NOTE: NEW MOUNTING DIMENSIONS FOR GEN5 GATE!

L-401A-IM-MTU-XL GEN5  
(MTU-GLR-XL-5000-A-G SHEET2)

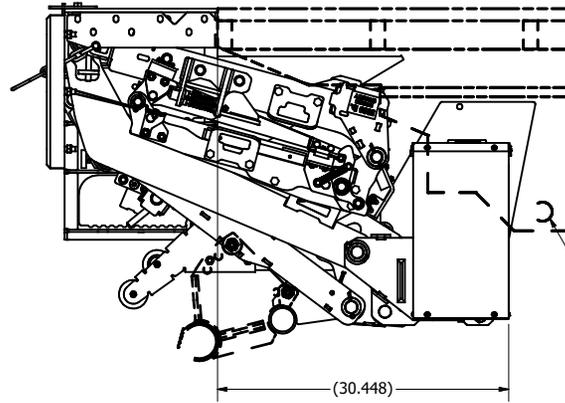
DUE TO COMPLETELY NEW GEOMETRY, THE MOUNTING LOCATION OF THE ADAPTER FRAME TUBE RELATIVE TO THE REAR SILL OF THE TRUCK HAS MOVED.

ALSO, MOUNTING DIMENSIONS FOR MTU-XL ARE DIFFERENT FROM MTU4/55 DUE TO USING 16" FLOORS INSTEAD OF 12" FLOORS.
